9.2.2 Proposed Traffic Calming – Bourke Street, Leederville

PROPOSED ALTERNATE RECOMMENDATION:

9.2.10 Rescission Motion: Leederville Town Centre Enhancement Project – Newcastle Street and Carr Place Intersection Proposed Modifications

TECHNICAL SERVICES
DRAWING NO.
2648-CP-01A

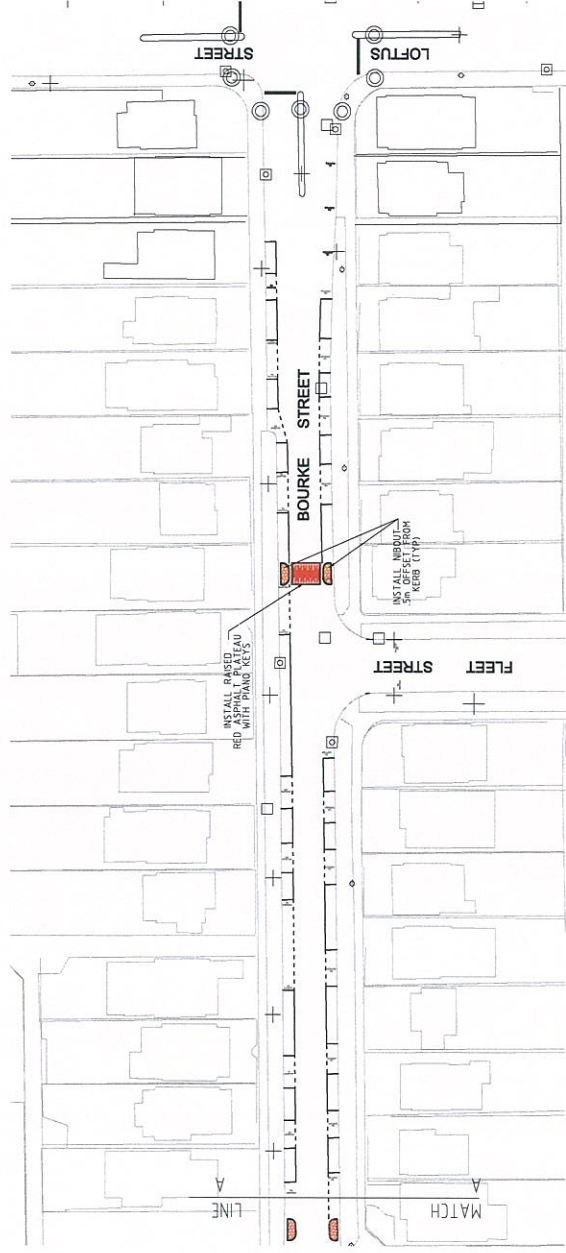
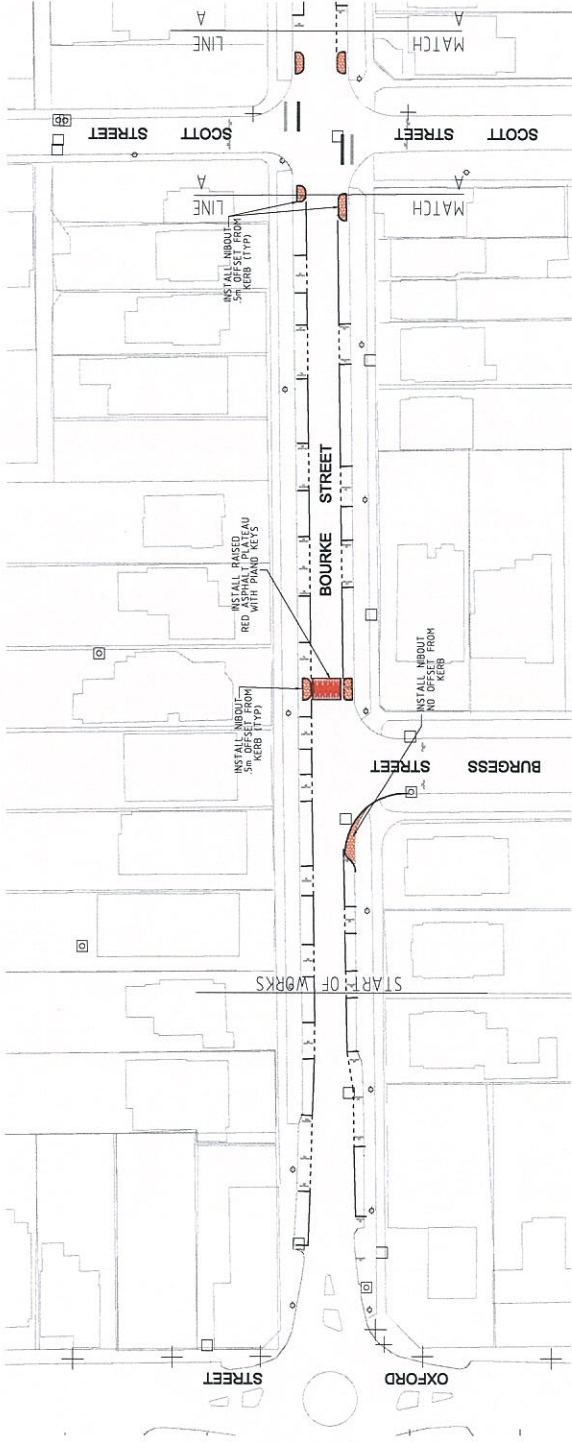
1. **APPROVES** the implementation of the proposed traffic calming measures in Bourke Street, Leederville between Loftus Street and Oxford Street, with the deletion of the speed hump near Scott Street, as shown on amended Plan No. 2648-CP-01A; and
2. **ADVISES** the respondents of its decision.

By removing one of the proposed devices (near Scott Street), while the outcome will not be as effective, it will still result in some degree of speed reduction in the street.

MARK	DATE	AMOUNT	MADE BY	ASSIGNMENT
A	10/09/18	AMB		REMOVED BOYD STREET SPEED LAMP

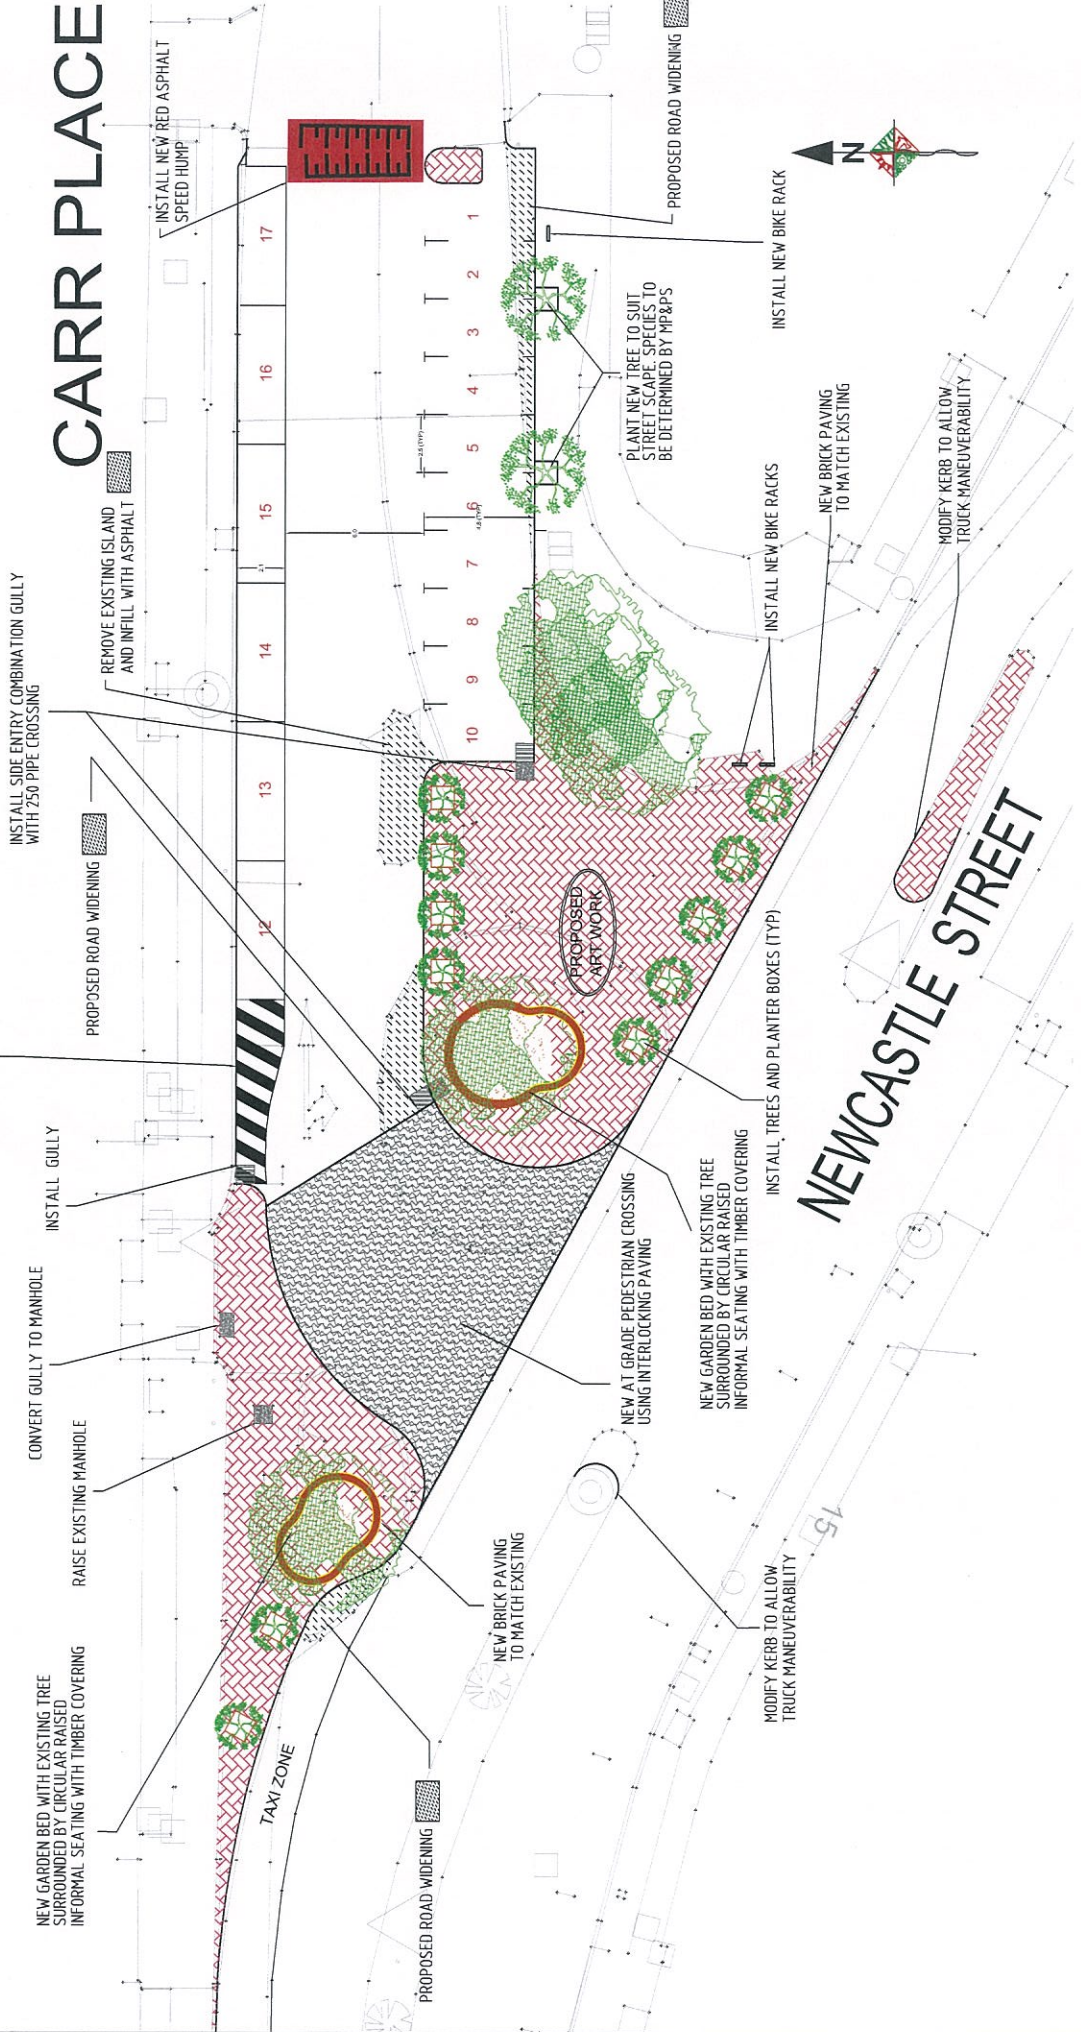
1. *APPROVES IN PRINCIPLE the revised proposal for the upgrade of the Carr/Newcastle Street intersection as shown on attached plan No. ~~3064-CP-01B~~ 3064-CP-01C estimated to cost \$310,000 including road rehabilitation and resurfacing;*
2. *CONSULTS with*
 - 2.1 *business and residents in the area bounded by Leederville Parade, Loftus Street, Vincent Street and the Freeway; and*
 - 2.2 *the Taxi Board requesting they provide information/feedback regarding protocols for use of taxi ranks and the suitability of the Newcastle Street rank in terms of number of bays required at this location; and*
3. *RECEIVES a further report at the conclusion of the consultation period".*

Administration is seeking Council's in principle approval for a revised proposal for improvements to the intersection. The proposed amendment reduces the proposed parking by one (1) car bay (net gain of 7 car bays) with a corresponding increase in the pedestrian/landscaped area. In addition Plan 3064-CP-01C increases the proposed soft landscaped areas surrounding the existing two (2) large spotted gum trees.
